Office Action Summary

10/518,860

FRID, NOUREDDINE

Fig 1

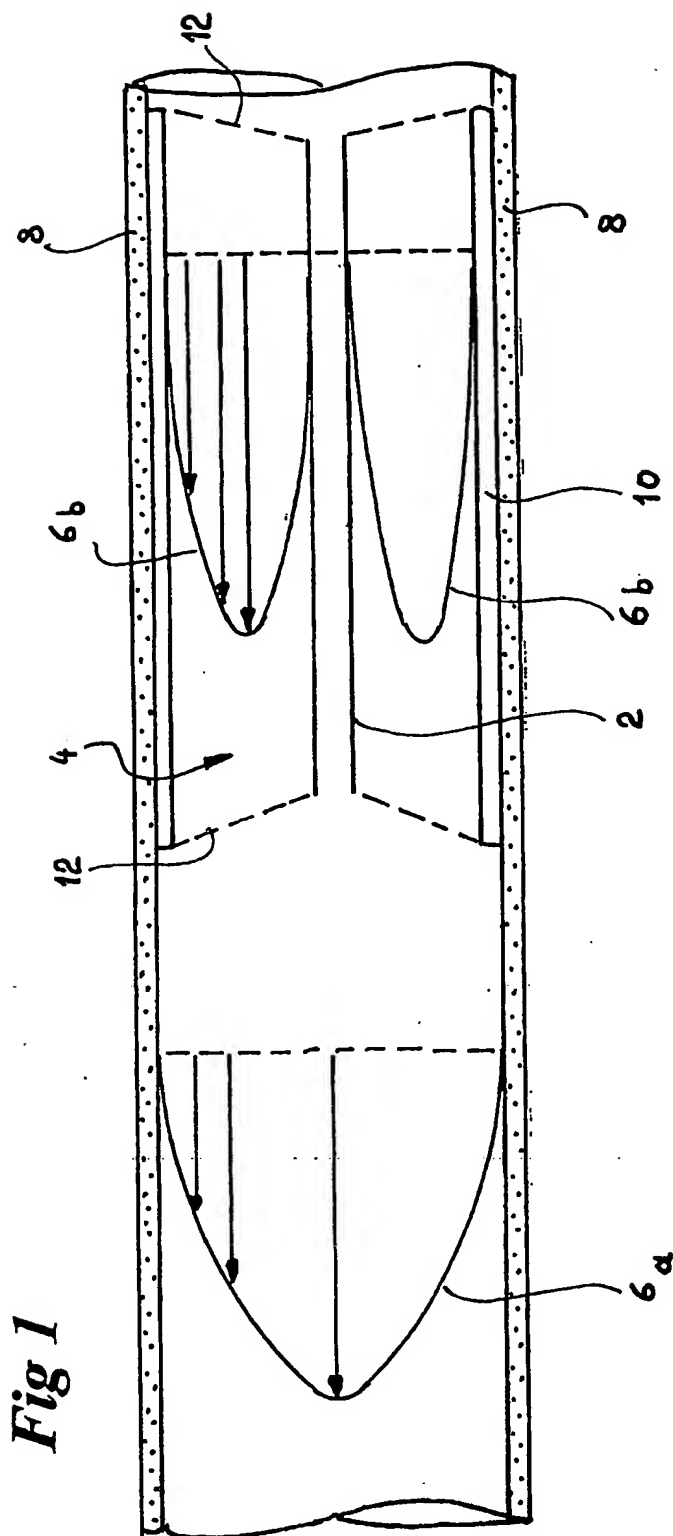
On page 7 of the present specification, line 23, the side of Figure 1 referred to appears to be incorrect in that "left" should be ---right--- to correspond to the deflector side of the figure.
